Meeting Agenda Planning Commission

Wednesday, June 10, 2020

**TECHNICAL REVIEW PLAT REQUIREMENTS
REGULAR PLANNING COMMISSION MEETING
JUNE 10, 2020**

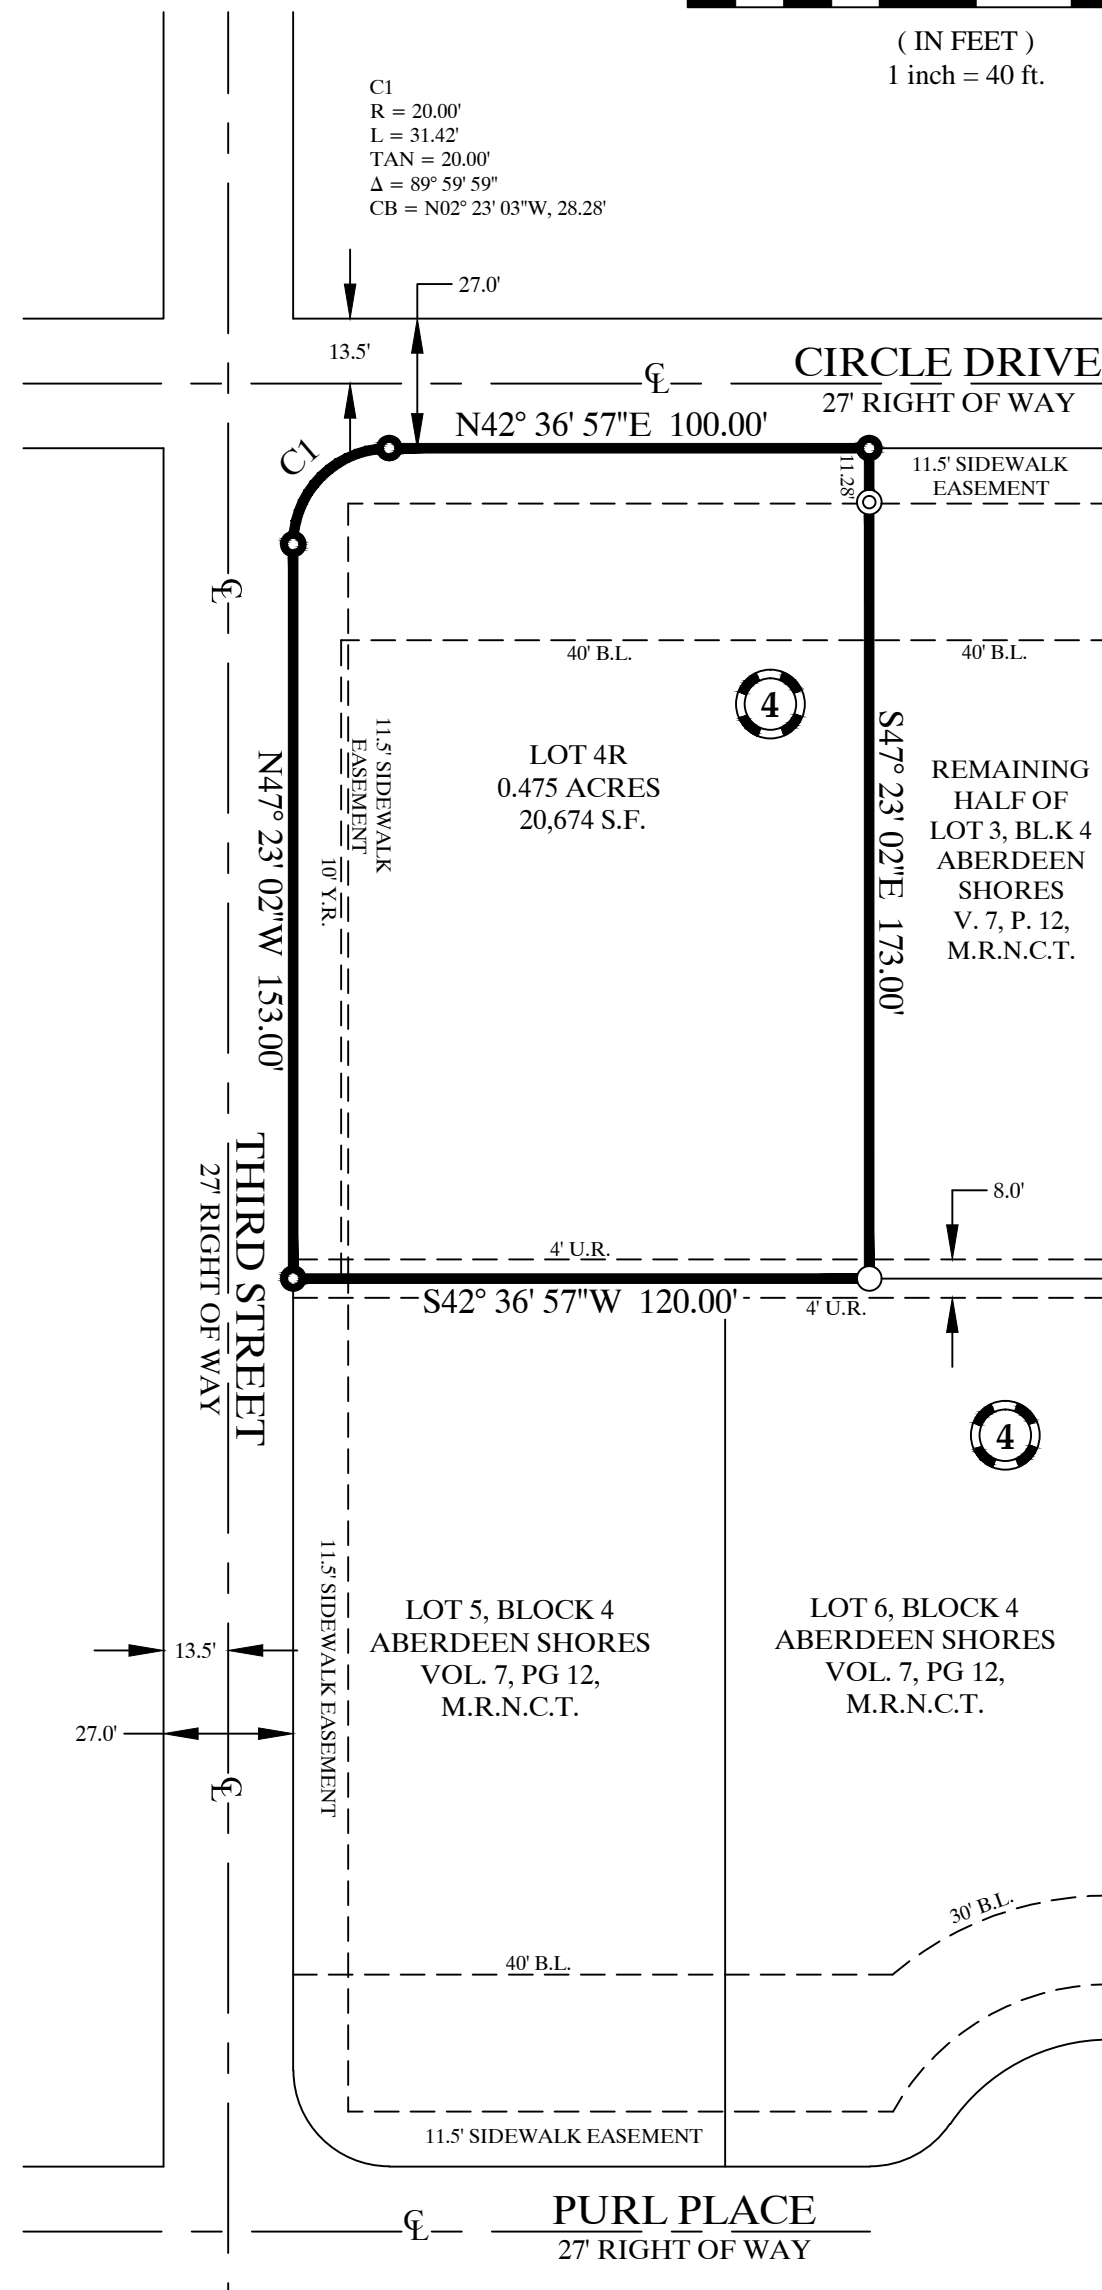
LAND DEVELOPMENT						
No.	Sheet	Comment	Applicant Response	Staff Resolution	Applicant Response	Staff Resolution
1	Plat	On plat title, place block number before lot number.	Put Block in front of Lot	Addressed.		
2	Plat	11.5' Sidewalk easement as per previous plat to continue on Lot 4R.	Added 11.5' sidewalk easement	Addressed.

3	Plat	Existing 40' B.L. to remain as B.L. as per previous plat.	Changed 40' Y.R. to B.L.	Addressed.		
4	Plat	Provide second notary for ownership or update notary certificate to accommodate two owners.	Added second notary block	Addressed.		
5	Plat	Property exempt from Development fees as home sits on platted Lot with open Utility account.	Ok	Addressed.

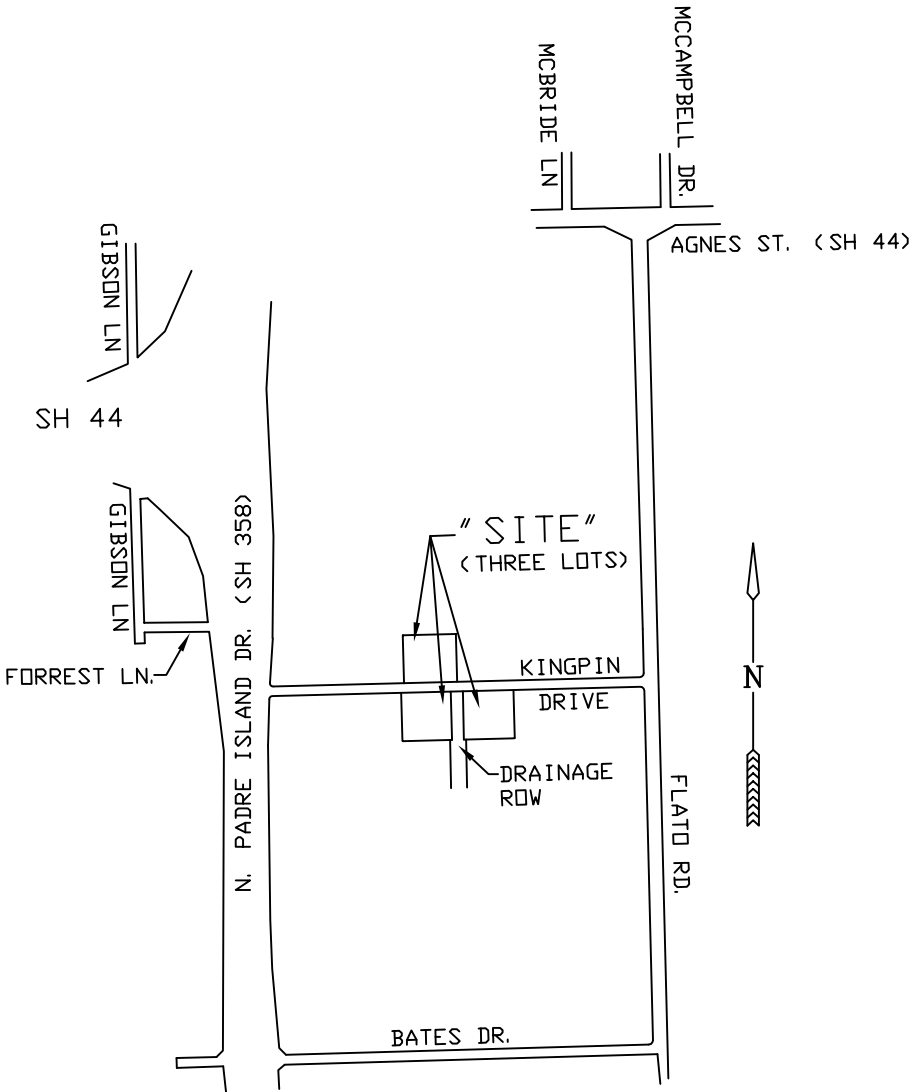
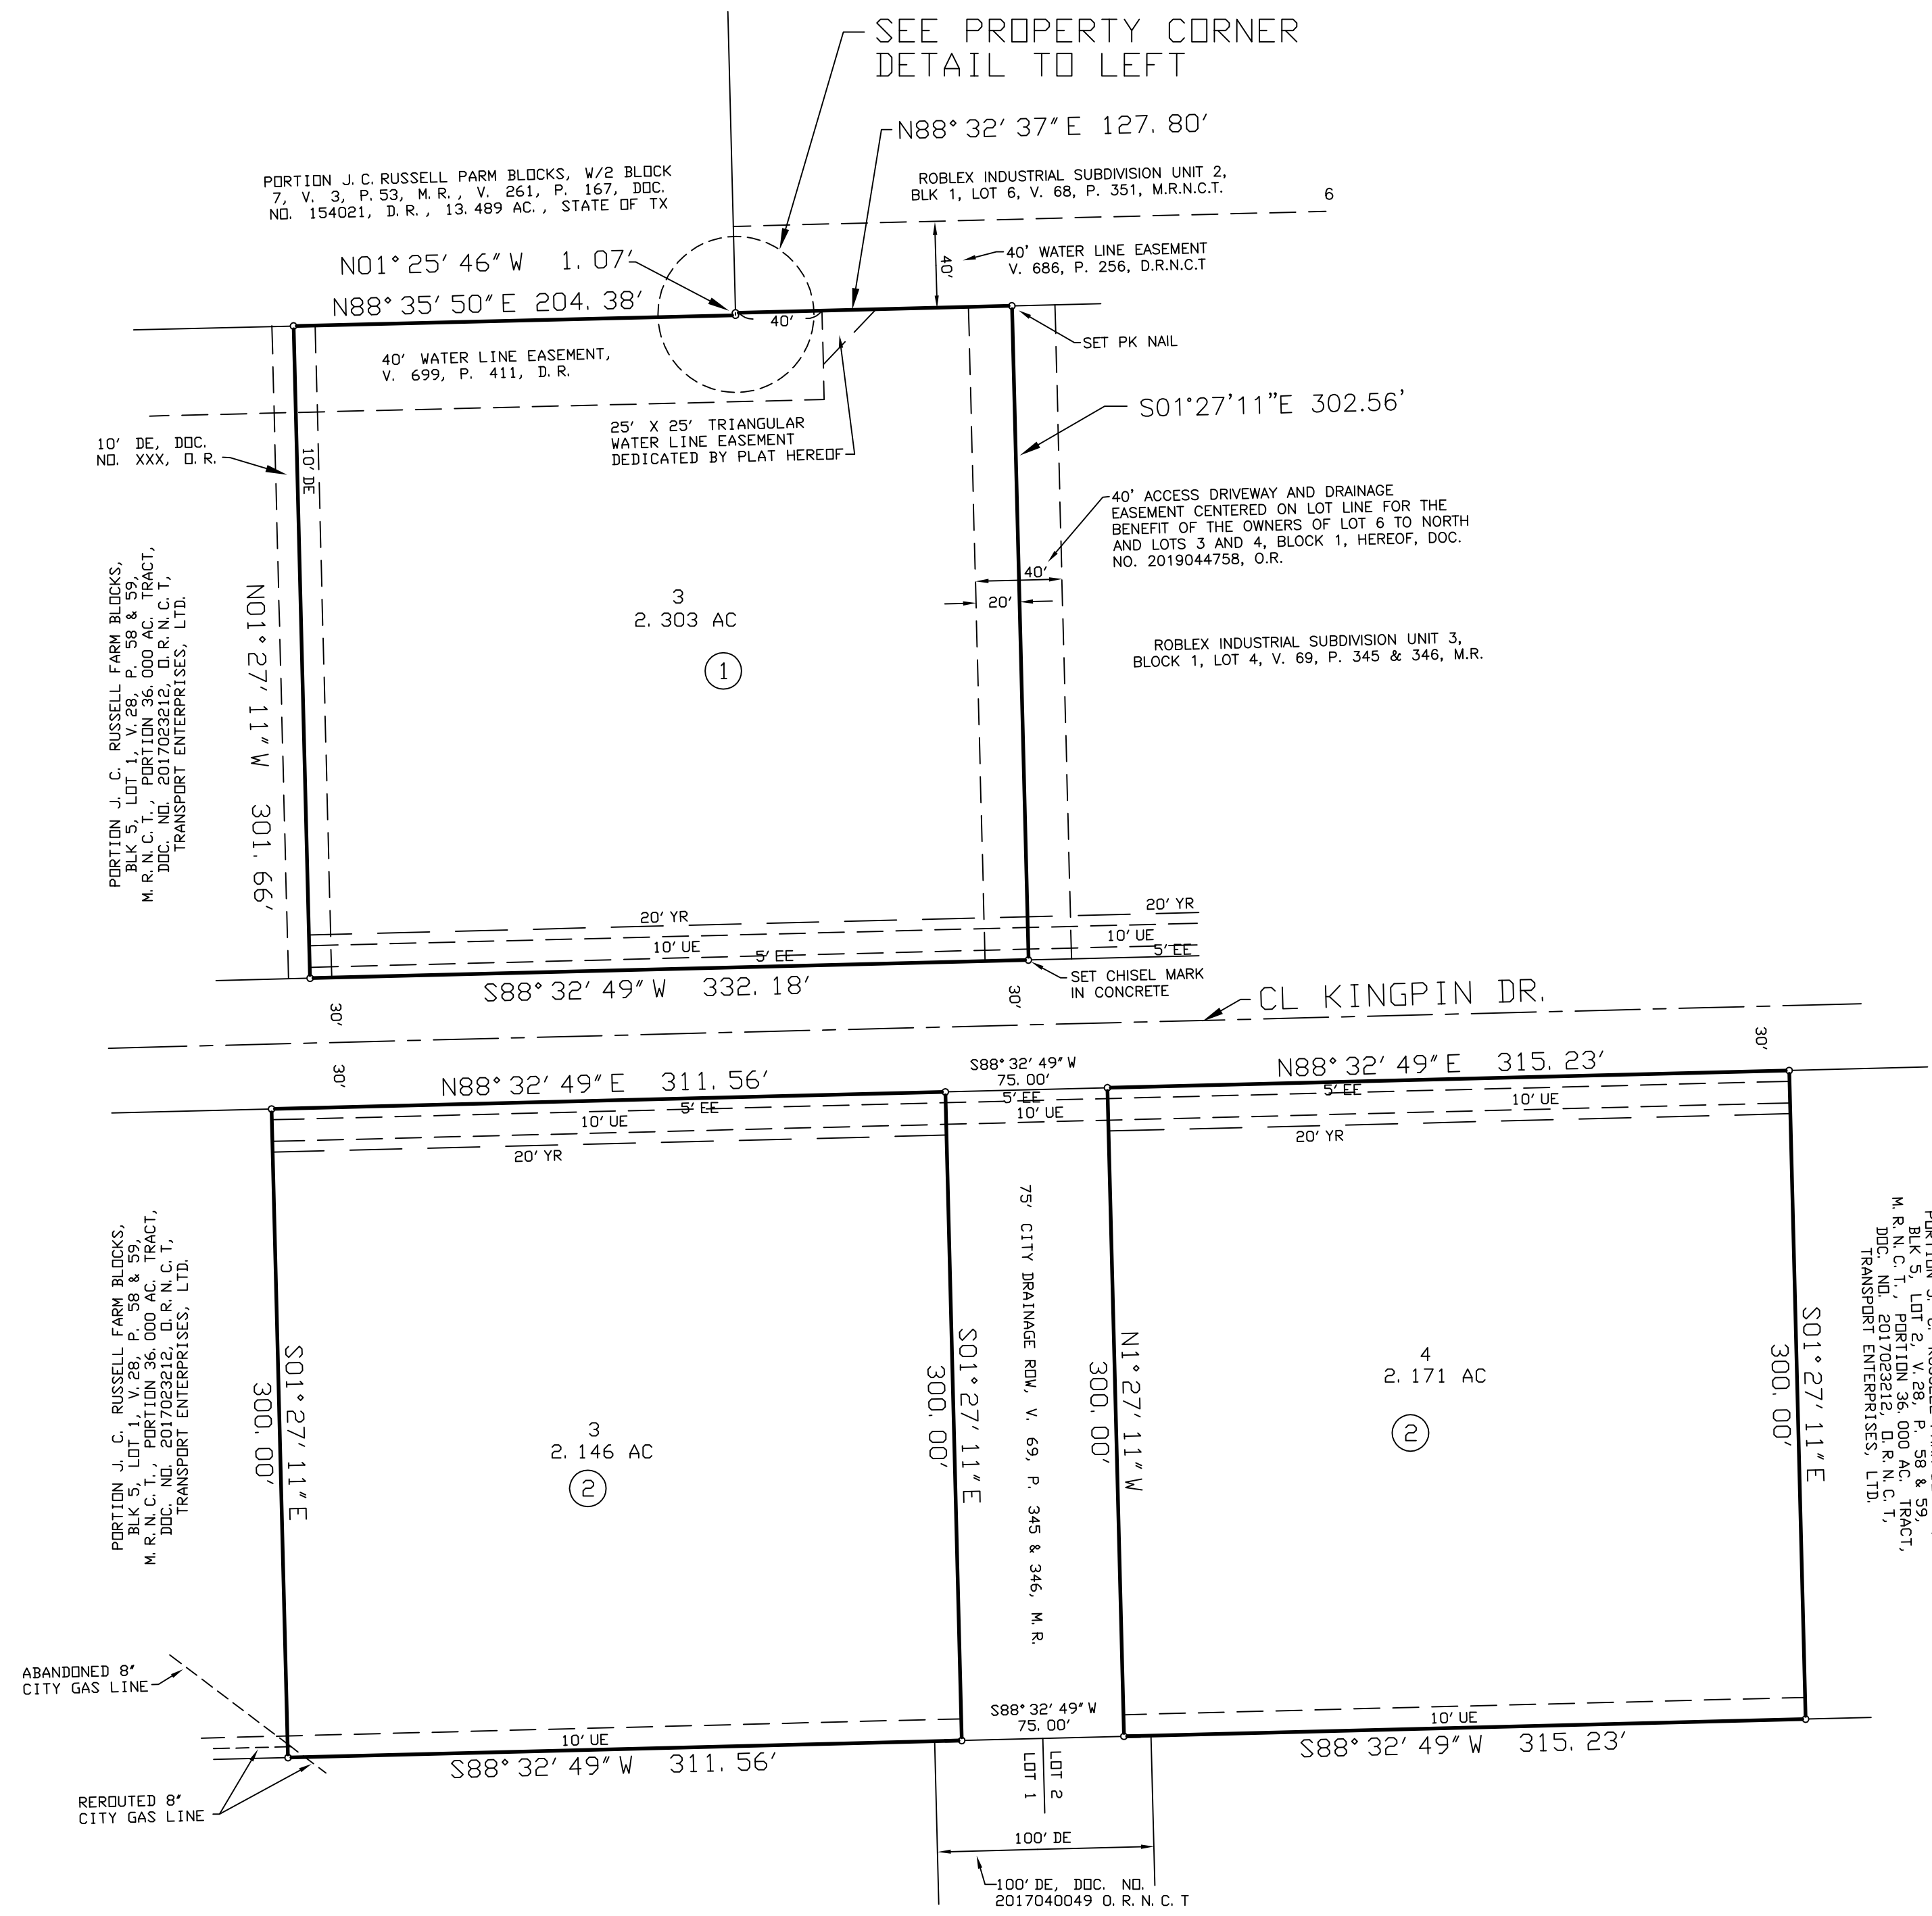
LAND DEVELOPMENT						
No.	Sheet	Comment	Applicant Response	Staff Resolution	Applicant Response	Staff Resolution
1	Plat	On the current plat show and label Note 11 as shown on Volume 69, Pages 345-346	Done.	Not Addressed: See Note 11 shown on Volume 69, Pages 345-346 and then add that note to this current plat.	Done.	Addressed
2	Sheet 2 of 2	On Block 2, Lot 3 "Abandon 8' Gas Line" re-label the reference as shown on the utility plan and label the rerouted 8' Gas location.	Done.	Addressed		
3	Sheet 2 of 2	Prior to plat recordation show and label 10'D.E recorded document number for Block 1, Lot 3	OK.	Prior to plat recordation		
4	Plat	Water Distribution acreage fee – 6.62 acres x \$1,439.00/acre = \$9,526.18	OK.	Prior to plat recordation

No.	Sheet	Comment	Applicant Response	Staff Resolution	Applicant Response	Staff Resolution
1	Plat	Add the following note "all driveways shall conform to access management standards outlined in Article 7 of the UDC".	Done.	Addressed		
2	Utility Plan	All existing utilities must be labeled as existing (not proposed).	The utility plan was approved with the preliminary plat. It doesn't need to be amended every time we plat a lot or lots.	Not addressed	Done.	Addressed
3	Informational	Additional FIRE Hydrants maybe required at the building stage.	OK

No.	Sheet	Comment	Applicant Response	Staff Resolution	Applicant Response	Staff Resolution
1	Plat	WATER DISTRIBUTION SYSTEM STANDARDS: Fire Hydrant flow light Industrial Areas: Shall have 1,500 GPM with 20 psi residual with a Fire hydrant every 300 feet and operational.	Ok.			
2	Plat	Fire hydrants are to be located 100 feet to FDC (if required). Hose lay from hydrant not to exceed 300 feet from furthest point of structure (500 feet if building has fire sprinkler system)	OK.			
3	Plat	503.1.1 Buildings and facilities. Approved fire apparatus access roads shall be provided for every facility, building or portion of a building hereafter constructed or moved into or within the jurisdiction.	Ok.			
4	Plat	The fire apparatus access road shall comply with the requirements of this section and shall extend to within 150 feet (45 720 mm) of all portions of the facility and all portions of the exterior walls of the first story of the building as measured by an approved route around the exterior of the building or facility.	Ok.

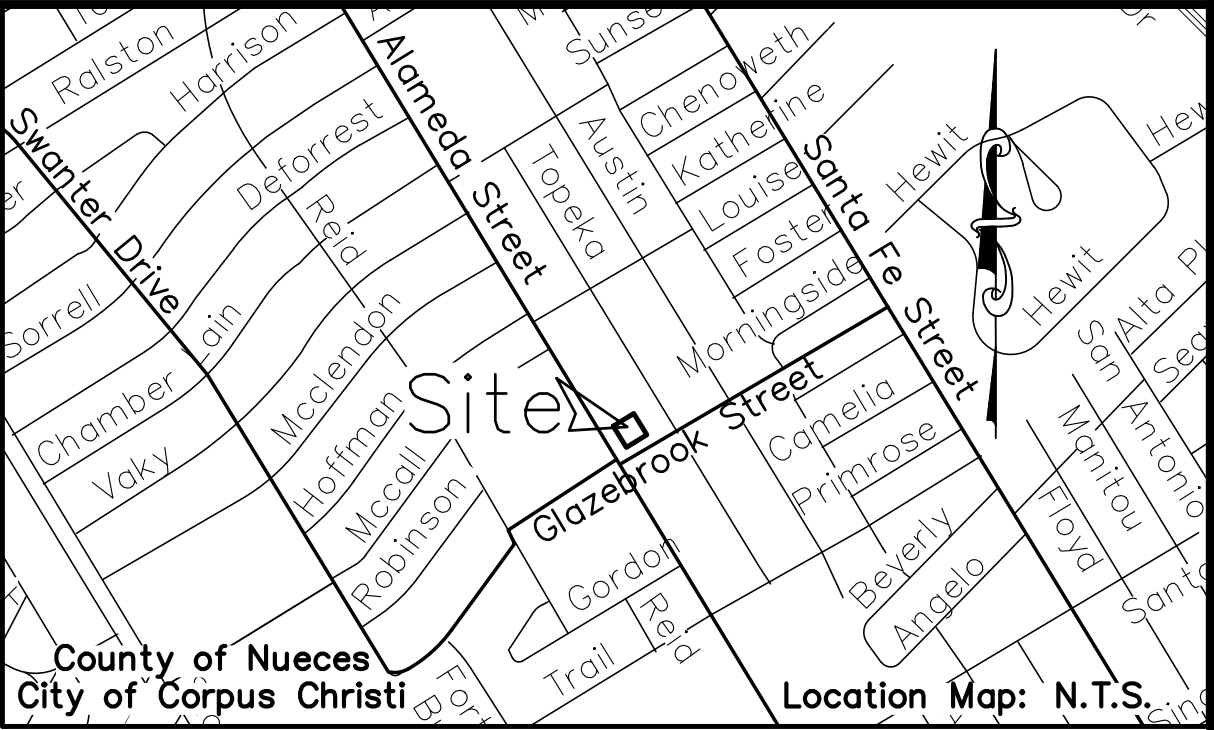
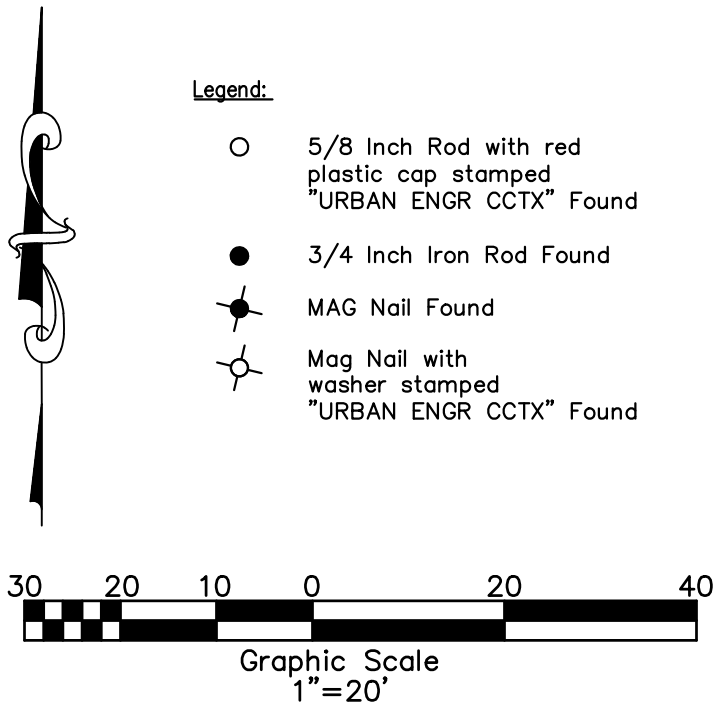
GIS						
No.	Sheet	Comment	Applicant Response	Staff Resolution	Applicant Response	Staff Resolution
1	Plat	The plat closes within acceptable engineering standards.	Understood	Resolved.		
2	Plat	All inside street corner intersections require a radius of a minimum of 10' on local residential streets, 15' to 20' on collector/commercial/industrial streets and 20' to 50' on arterials. The radius may vary depending on the circumstances.	radius has been added	Resolved.

LAND DEVELOPMENT						
No.	Sheet	Comment	Applicant Response	Staff Resolution	Applicant Response	Staff Resolution
1	Plat	Provide a corner radius for the intersection to an Arterial street. Adjust acreage and square footage on plat label.	radius has been added	Addressed.		
2	Plat	Provide a 15' UE along Alameda Street.	Easement has been added	Addressed.		
3	Plat	Water Distribution System acreage fee – .37 acres x \$1,439.00/acre = \$532.43	Understood	To be addressed prior to recordation.		
4	Plat	Wastewater System acreage fee – .37 acres x \$1,571.00/acre = \$581.27	Understood	To be addressed prior to recordation.		
5	Plat	Remove Director of Development Services certificate and replace with a Planning Commission certificate.	correction has been made, but we are asking the City to reconsider acceptance of the plat as a minor plat	Addressed.		
6	Plat	Correct plat description to "Replat"	correction has been made, but we are asking the City to reconsider acceptance of the plat as a minor plat	Addressed.

DEVELOPMENT SERVICES ENGINEERING						
No.	Sheet	Comment	Applicant Response	Staff Resolution	Applicant Response	Staff Resolution
1	Utility Plan	Label the Wastewater line (6" VCP).	label has been added	Addressed.		
2	Plat and Utility Plan	Show the existing 10' UE on the south side; if you wish to close it contact Mr. Vern Robins at VernR@cctexas.com	What easement are you referring to. There is no existing easement by previous plat along the south side. Nor were we able to locate an easement by separate instrument. City is asking for a 15' along Alameda with this submittal although all utilities are in along rear.	Addressed.		
3	Informa tional	The future connection to the wastewater at the back must be made to the line NOT the Manhole.	Understood	To be addressed with Site Development.

No.	Sheet	Comment	Applicant Response	Staff Resolution	Applicant Response	Staff Resolution
1	Plat	Add the following as an additional note to the plat: "If any lot is developed with residential uses, compliance with the Public Open Space regulations will be required during the building permit phase."	Note has been added	Addressed.
